PRIVATE STORM SEWER EXTENSION FOR
APPLEGATE'S LANDING AT PAWNEE & ELIZABETH

CITY OF WICHITA
R. W. LINN CITY ENGINEER
PROJECT NO. DBKW707006

APPROVED AS NOTED
BY CITY ENGINEER, WICHITA

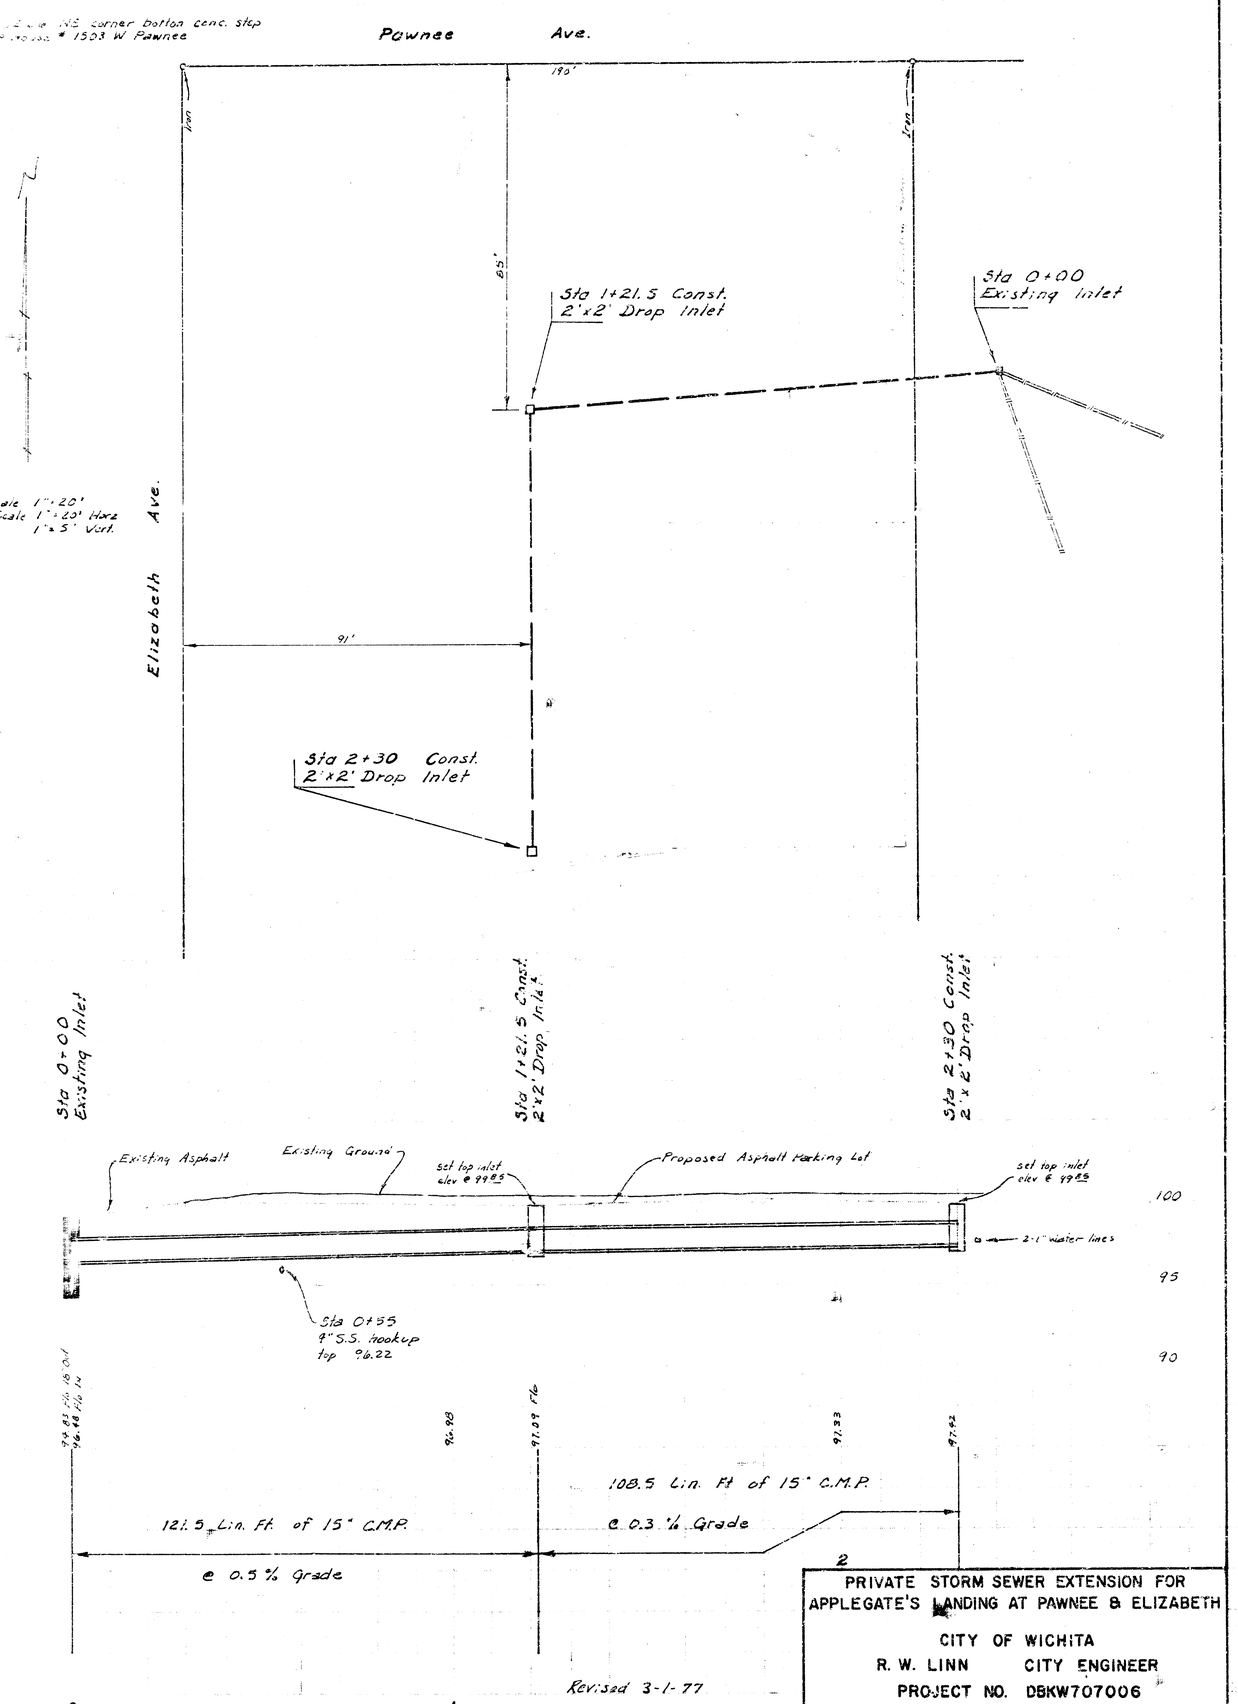
Note: Replace the 4" Clay Pipe Sanitary Sewer hookup with 4" Ductile Iron Pipe a minimum distance of 2.5 ft. on both sides of the center line Storm Sewer. Concrete Collars must be installed on the joints between the Iron & Clay pipe.
